# Vieux Carré Commission Architecture Committee Meeting

Tuesday, September 24, 2024

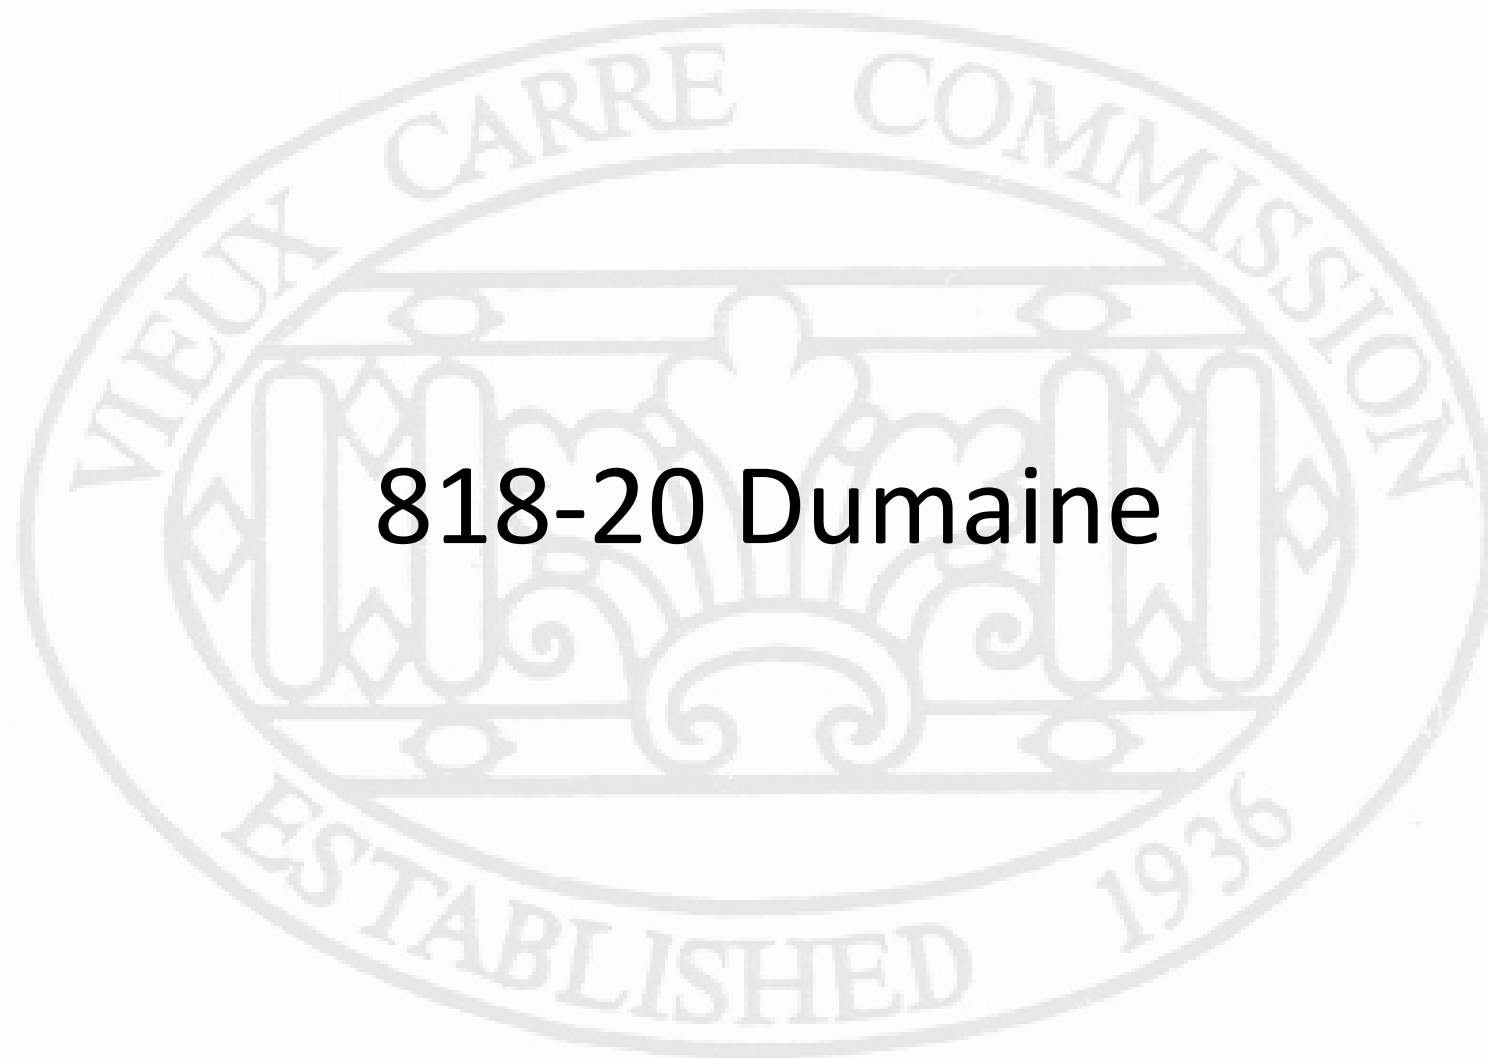
Staff notes some concerns that the proposed plan includes a note about replacing several tent posts. Although tents are meant to be temporary installations, it appears this one has become much more permanent and there is no indication that it has been broken down in several years. The Guidelines state that, *“to maintain the sense of openness to the sky in a courtyard or yard, the VCC regulates all roof structures that are mounted to a building element or wall, or are too large to be moved by a single person such as an awning, oversized umbrella or semi-permanent, ground-mounted structure such as a tent”* and *“the VCC does not allow installing a permanent courtyard covering or enclosure.”* (VCC DG: 10-3)

Additionally, staff found examples of permits from 2006 for the **temporary** installation of the tent which included a note that, “In the future, if the owner wishes to erect the tent, separate applications must be made and appropriate permits issued by the VCC and the City of New Orleans for each proposed use.”

It does not appear this process has been followed and staff seeks commentary from the applicant regarding the intention of the tent.

Staff finds the proposed repair work generally approvable but has concerns about the included helical tie details and the fact that the tent has seemingly become a more permanent feature. Staff requests commentary from the Committee regarding the proposal.
